11.21.19 Design Commission Comments on Preferred Alternative

Park Site Plan

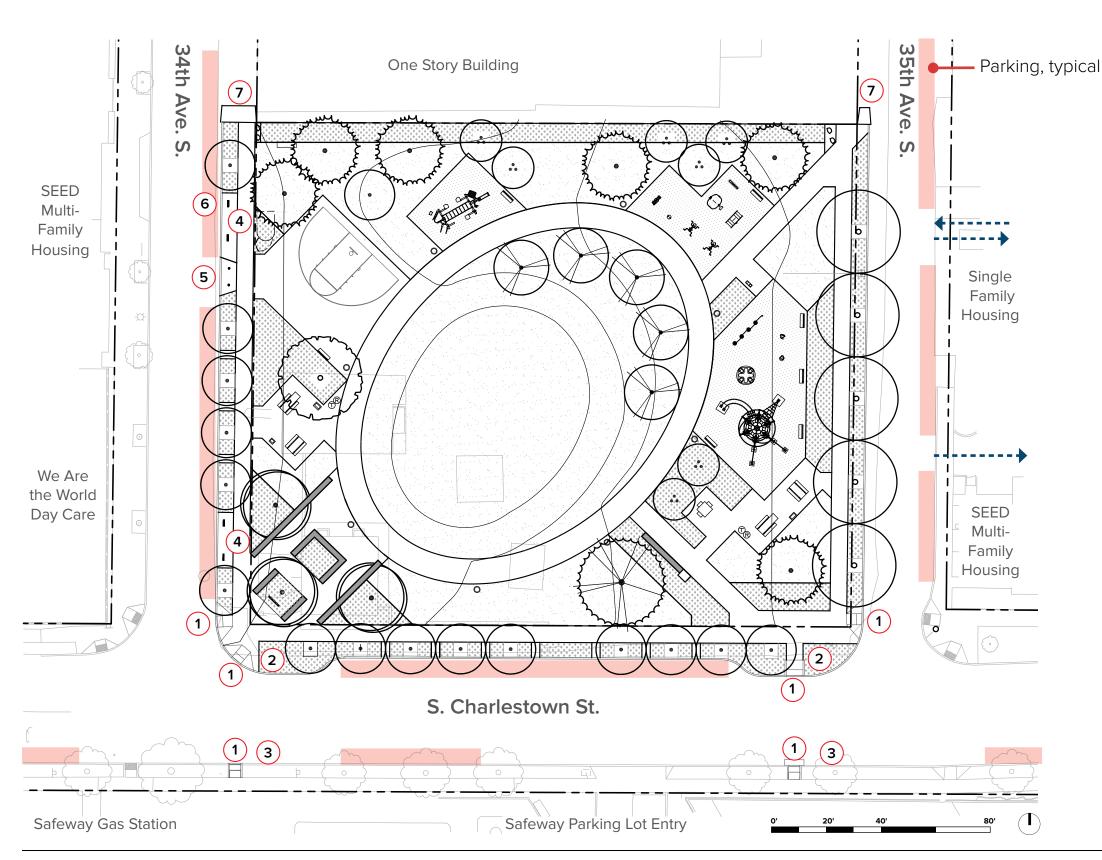
- Consider larger gathering spaces for family sized events.
- Continue to explore design options for the northern edge of the park including programming and planting that will provide a connection to future development.
- Consider adding a drinking fountain near play areas, to support active elements within the park.
- Seek opportunities for art and culture integration into the park that reflect community identity and goals.
- Think about naming of the park to reflect the history and culture of the neighborhood.
- Work with SDOT on opportunities to integrate cultural elements into sidewalk and crosswalks.
- Work with SDOT to implement crosswalks and other traffic calming measures on Charlestown to provide pedestrian friendly connections between the park and the commercial development.
- Consider sustainability in the selection and placement of site furnishings.

- A Family Gathering
- **B** Northern Edge
- C Drinking Fountain
- Integration of Art + Culture
- **E** Naming of the Park
- **F** Cultural Elements in ROW
- G Traffic Calming on Charlestown
- **H** Sustainability for Site Furnishings

Right-of-Way

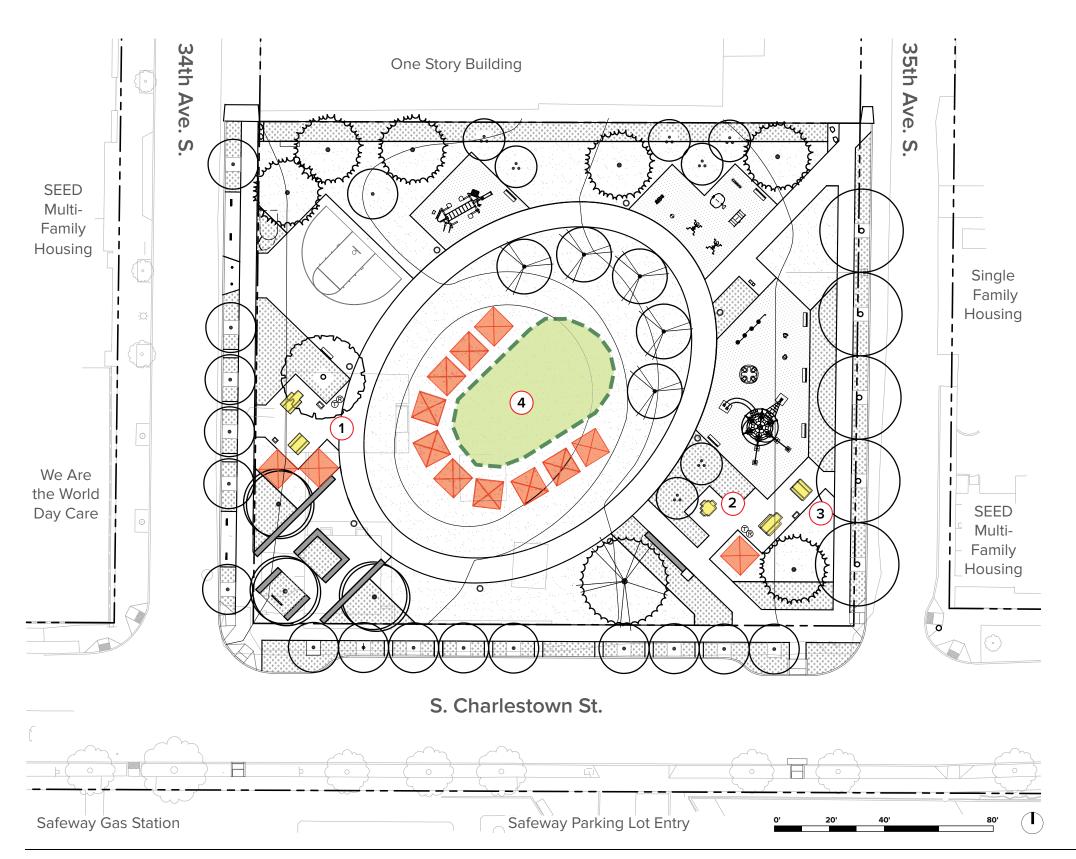
- F Cultural Elements in ROW
- G Traffic Calming on Charlestown

Curb bulbs on both sides of S Charlestown Street provide traffic calming and connect to the commercial core. SDOT will fund curb bulbs on the south side of the street as part of this project (in development).

Site Use Diagram: Family Picnic

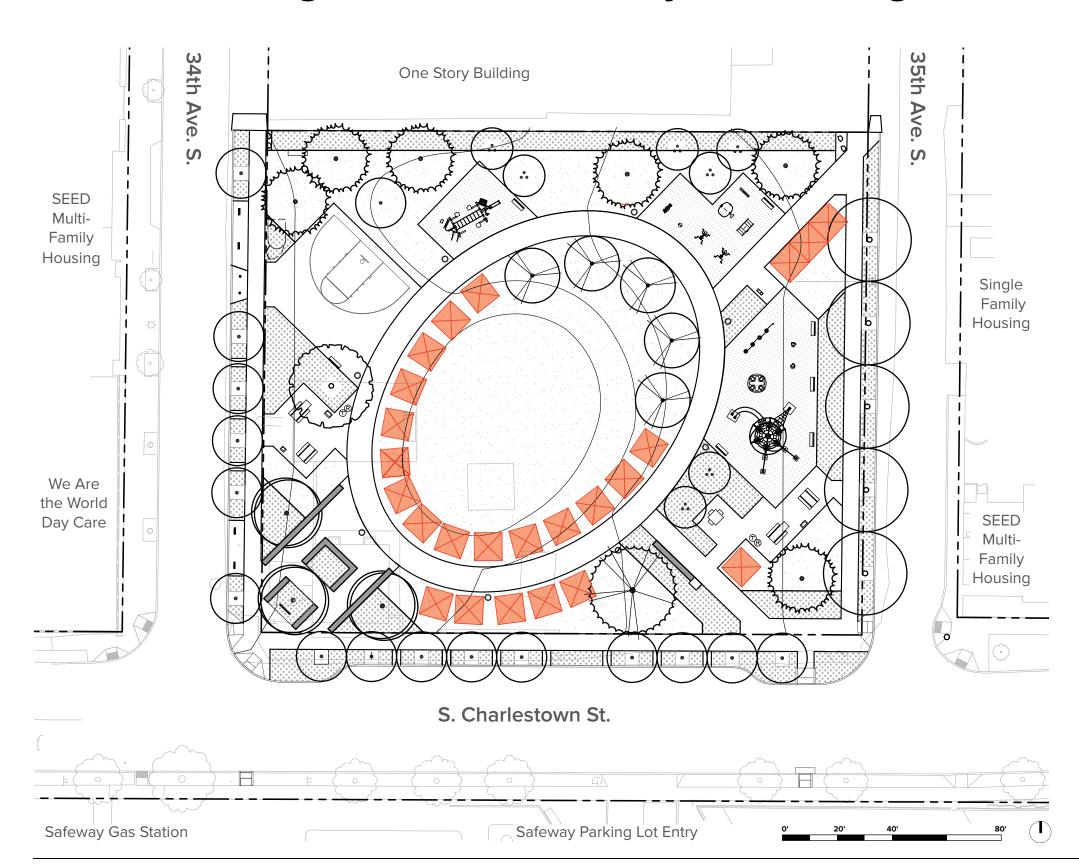
A Family Gathering

A variety of options are available for family picnics, including permanent facilities and adjacent lawn areas for additional canopies or activities
